Access Compliance Report

Public Rights-of-Way

(Curb Ramps)

Intersection ID: 46821	Main Street: RED_PINE_CT	Cross Street: AZALEA_HILLS_DR	Location: W
ADA ID: CA439A71F574	Ramp Type: Perp	Initial Pass/Fail: Fail	Overall Compliance: No
Severity Score: 10			
Codes/Mitigation Info/Possible Solution		Field Measurements/Component Compliance

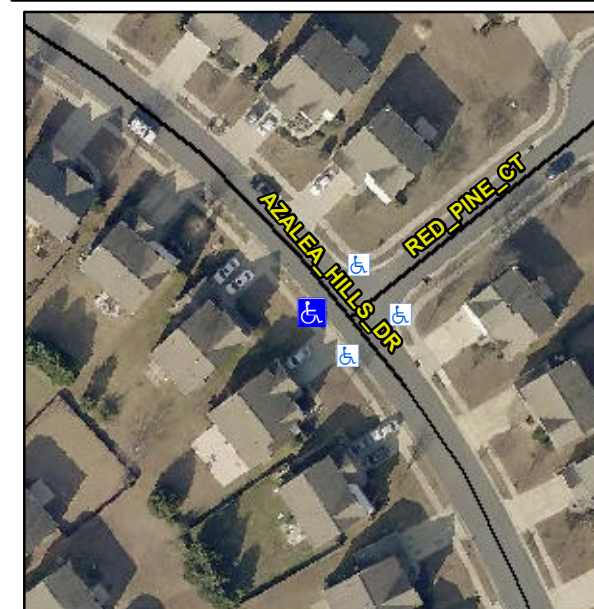
Not Found, R304.5.1, R304.5.3

Compliance	Description	Data	Compliance	Description	Data
N/A	Ramp Length (in)	48.5	Yes	Ramp Slope (%)	8.0
No	Ramp Width (in)	47.0	No	Ramp XSlope (%)	3.1
N/A	Flare Type LT	N/A	N/A	Flare Type RT	N/A
N/A	Flare Slope LT (%)	N/A	N/A	Flare Slope RT (%)	N/A
N/A	Flare Traversable LT?	N/A	N/A	Flare Traversable RT?	N/A
N/A	Landing Length (in)	N/A	N/A	DWS Provided?	N/A
N/A	Landing Width (in)	N/A	N/A	DWS Contrast?	N/A
N/A	Landing Slope (%)	N/A	N/A	DWS Length (in)	N/A
N/A	Landing X Slope (%)	N/A	N/A	DWS Full Width?	N/A
N/A	Landing Curb? (Y/N)	N/A	N/A	DWS Offset (in)	N/A
N/A	Shared Landing?	N/A			
N/A	Gutter Ponding?	N/A	N/A	Gutter Slope (%)	N/A
N/A	Gutter Lip Ht (in)	N/A	N/A	Gutter X Slope (%)	N/A
N/A	Painted X Walk1?	No	N/A	Painted X Walk2?	N/A
	X Walk 1 Direction	To NE		X Walk 2 Direction	N/A
N/A	X Walk 1 Width (in)	N/A	N/A	X Walk 2 Width (in)	N/A
	X Walk 1 Slope (%)	1.8		X Walk 2 Slope (%)	N/A
	X Walk 1 X Slope (%)	1.9		X Walk 2 X Slope (%)	N/A

Remove & Replace Entire Ramp.
